Application No.: 10/505,249
Amendment and Response dated November 2, 2005
Reply to Office Action of August 11, 2005
Docket No.: 1536-2 PCT/US
Page 8

Amendments to the Drawings:

Application No. 10/205,249
Amendment and Response dated November 2, 2005
Reply to Office Action of August 11, 2005
ANNOTATED SHEET SHOWING CHANGES

Figure 1

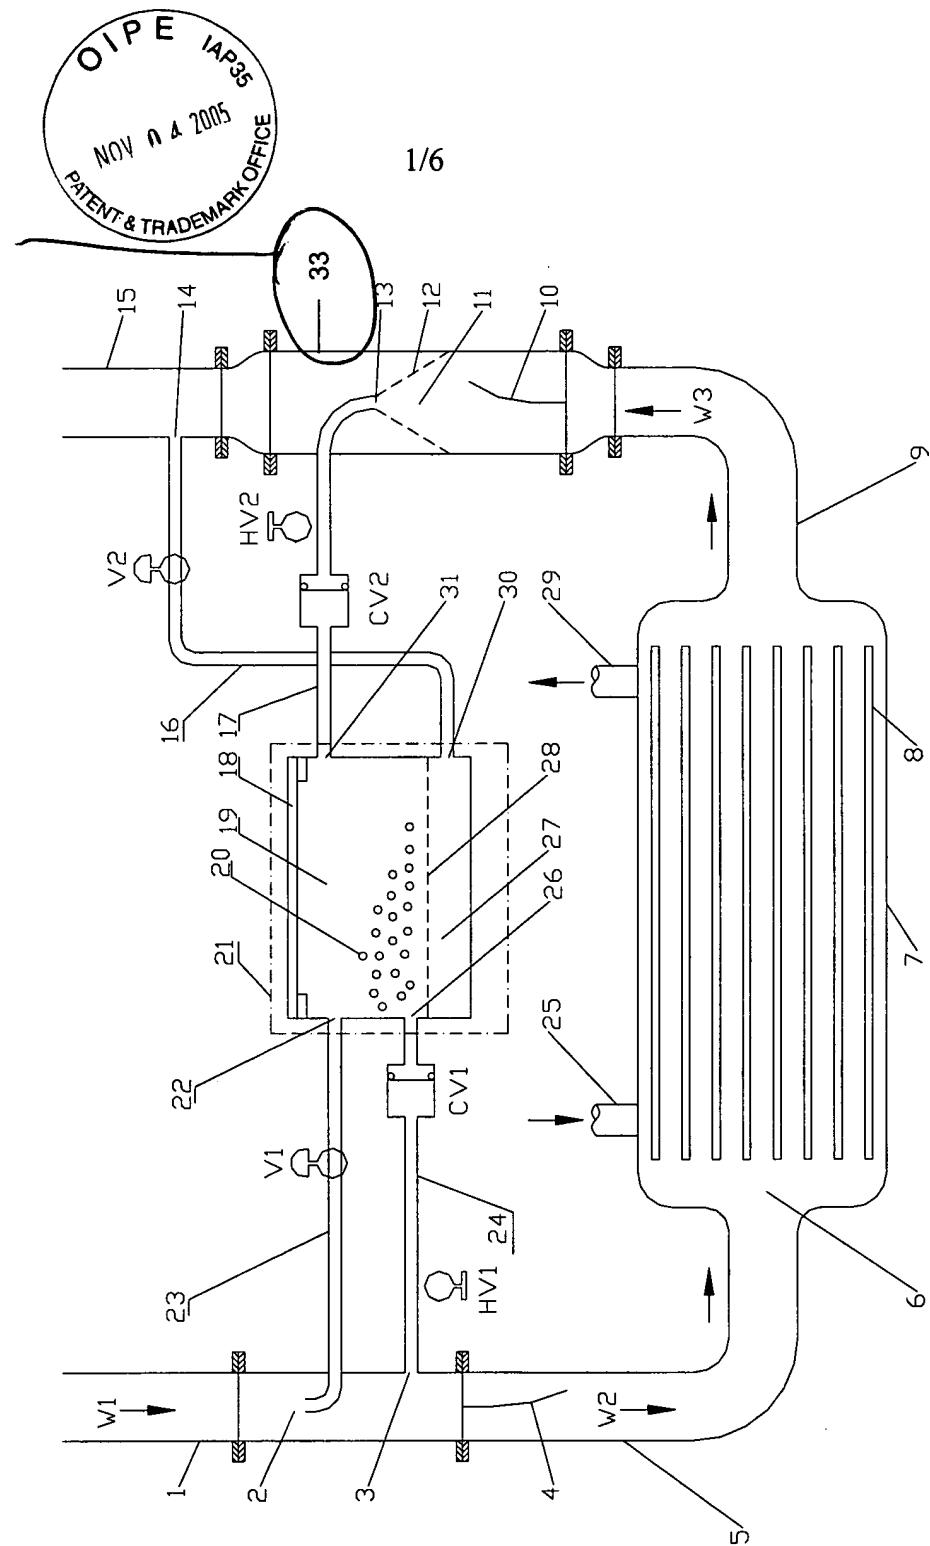
The attached sheets 1/6, 2/6, 3/6, 4/6 and 5/6 of the drawings include changes to Figures 1, 2, 3, 4 and 5, respectively. These sheets, which include Figures 1-5, replace the original sheets including Figures 1-5. In Figures 1-5, a previously omitted element 33 has been added.

Element 33
added

element 33
a solid
